Change Order Memorandum

Project Name	Margate Boulevard Crosswalk and Landscape Improvements		
Date	3/6/2026	Change Order No. 6	Project No. 21-0089.00012
Contractor	FG Construction

Scope: Landscaping Modification by R-43

STATE RD 7
 L-4

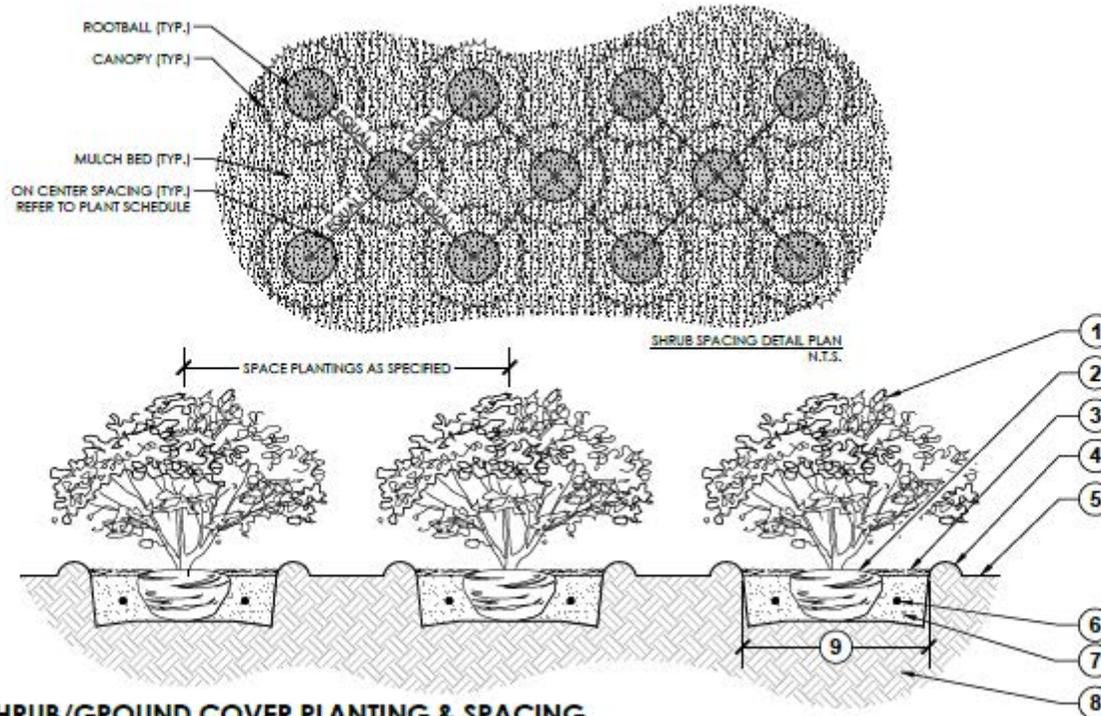
Under existing conditions, pedestrians are able to walk behind the electrical pole at the SR-7 and Margate Boulevard intersection (R-43 on the plans). To achieve ADA compliance for the proposed ramp, a curb is required to accommodate the necessary elevation changes. A site visit confirmed that installation of this curb could create a potential tripping hazard for pedestrians traveling southbound on SR-7 and turning right onto Margate Boulevard.

Placement of shrubs should follow detail #2 on L-8
 Add: (1) Clusia
 (14) GIF
 All irrigation heads within this location should follow the edge of the sidewalk space at 12' OC each head. Add additional as required to provide 100% coverage with min of 50% overlap

Place (4) PE

Relocate both

The existing concrete sidewalk located behind the electrical pole shall be removed, and the adjacent landscape planter shall be extended into this area. The Contractor (FG) shall remove existing curbing and pavers and prepare the area for new landscaping. Proposed plant materials shall be installed to match the existing layout and spacing, and irrigation lines shall be extended as required.
